**Re: Del Webb @ Mirehaven Units 3 & 4
Grading and Drainage Plan
Engineer's Stamp dated: 7/9/2018 (H09D017G)**

Project Title: Del Webb @ MIREHAVEN PHASE 3 & 4 **Building Permit #:** _____ **City Drainage #:** H-9
DRB#: 10006864 **EPC#:** _____ **Work Order#:** _____
Legal Description: Tracts N-2-B-1, N-2-B-2, N-2-C-1
City Address: _____

Re: Del Webb at Mirehaven Phase 3&4 Grading and Drainage Plan and Drainage Report
Engineers Stamp Dated: 05/10/2018 (H09D017G)

TYPICAL CROSS SECTION G-G
NOT TO SCALE-SECTION DEPICT EXISTING SWALE

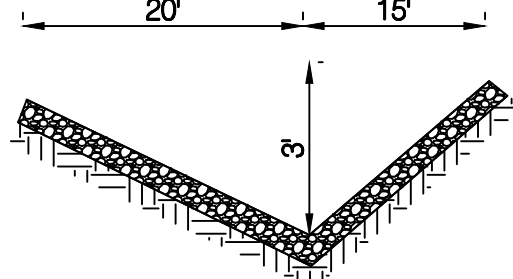
1. Stabilization of the concentrated flow path at the west Boundary between Units 3 & 4 is required, and should be noted in both the Unit 3 & 4 plans. **The cross-section with construction notes are provided on both Unit 3 & Unit 4 plans.** Section F-F should show solid concrete between the lower wall and the street due to the excessive scour potential at the bottom of the wall. **Concrete has been added at the bottom on the wall on either side of the trail** A note should be added at the upstream cutoff wall to "match existing grade". **Note added.** In the plan view, the stabilized area should be shifted south to where the sides are 3' above the invert instead of 2' south and 4' north as the plan currently shows. **This has been corrected to show 3' on both sides** Add a note to the upstream edge of the rundown to "field verify existing grades and position rundown to provide 3' vertical difference between existing invert and edges". **Note has been added.**

*CONTRACTOR SHALL FIELD
VERIFY TO ENSURE SWALE IS
3' DEEP FROM INVERT TO TOP
OF SWALE ON BOTH SIDES
